Planning & Development Services

RE: DRH16-00328 / 1101 W. Front Street

This letter is to inform you of the action taken by the Boise City Design Review Committee on the request for approval to construct a five-story, 86,430 square foot hotel with related site improvements in a C-5DD (Central Business District with Downtown Design Review) zone.

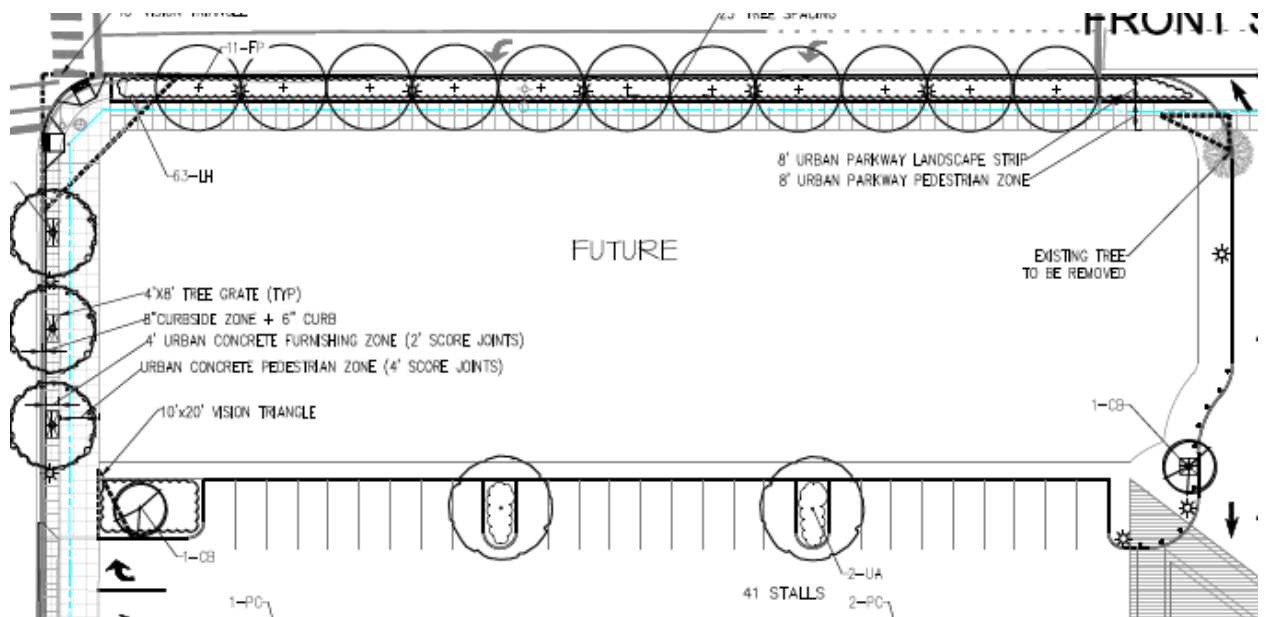
There is an 8-foot sidewalk that runs the full length of Front Street. The designated streetscape for Front Street is the Urban Concrete and the street section is shown below next to the proposal:

Though the design being installed along Front Street does not comply with the adopted guidelines, it does provide consistency from block to block. It also provides a better environment for the street trees to mature and have a strong root structure with the additional soil provided in the planter beds. The proposed streetscape creates a protected pedestrian area along the major roadway.
